April 28, 1995
JPN-95-024

SUBJECT: James A. FitzPatrick Nuclear Power Plant
Docket 50-333
**Revision 3 to the Reload 11/Cycle 12
Core Operating Limits Report (COLR)**

CORE OPERATING LIMITS REPORT
REVISION 3

FIGURE 8.4.a
CYCLE 12 LOADING PATTERN, UPPER LEFT QUADRANT, BUNDLE DESIGN

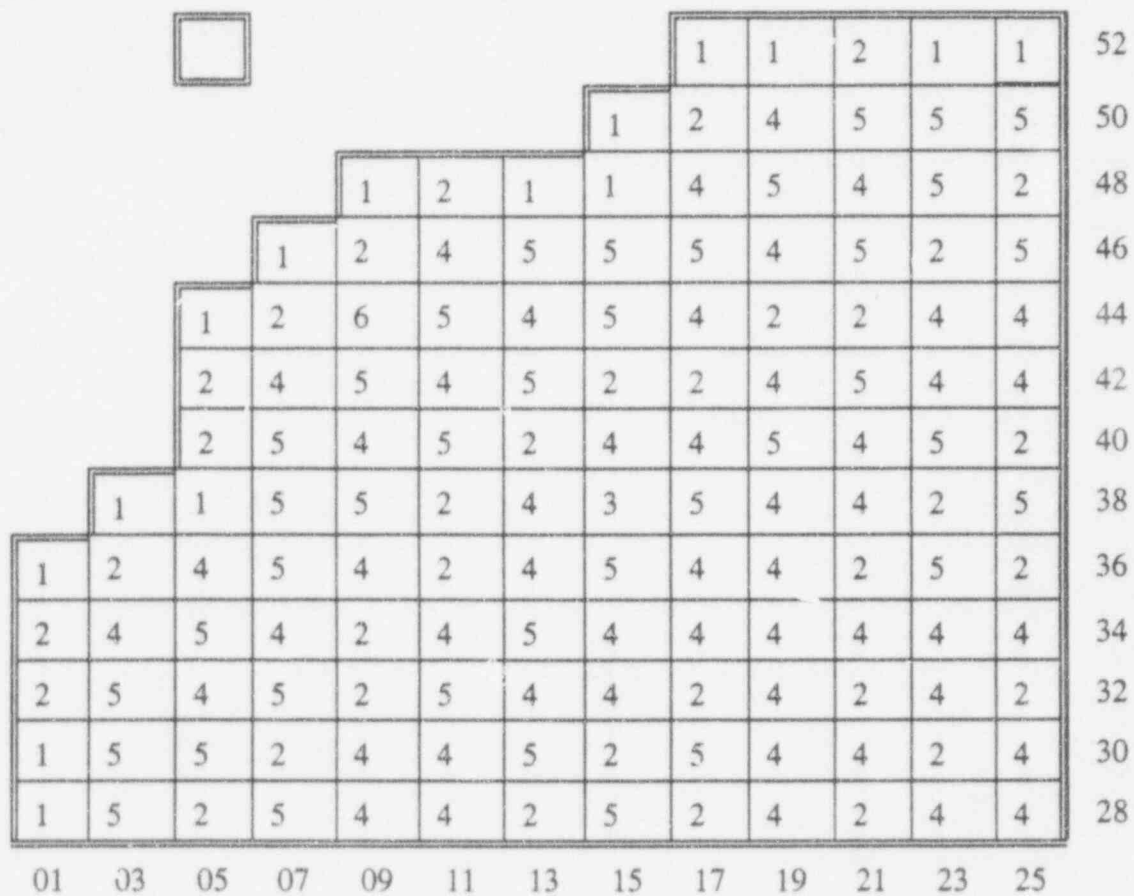
Revision 3 to the FitzPatrick Core Operating Limits Report (COLR) for Reload 11/Cycle 12 is attached. This revision supersedes and replaces Revision 2 (Reference). Revision 3 reflects a change to the core loading pattern and corrects typographical errors in the bundle types on Figures 8.4.a through 8.4.d.
